Product Change Notice (PCN)

PCN Number: **PCN-0384612R-01**

Product(s) Affected: *CMS-18138A-SP*

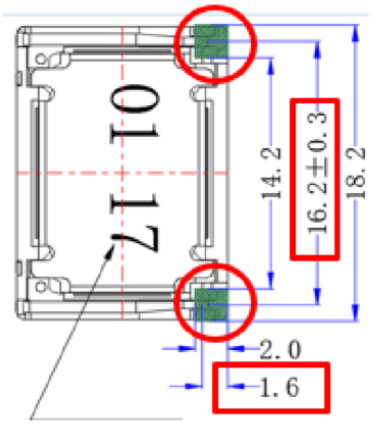
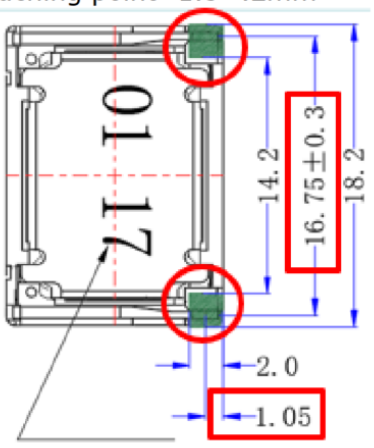
Reason(s) for Change: *In altering the springs, we are able to meet more customer's applications.*

Description of Change: *Spring contacts replaced. PCB layout unchanged.*

Previous:
Pin Pitch- 16.2±.3mm
Touching point- 1.6±.2mm

New:
Pin Pitch- 16.75±.3mm
Touching point- 1.5±.2mm
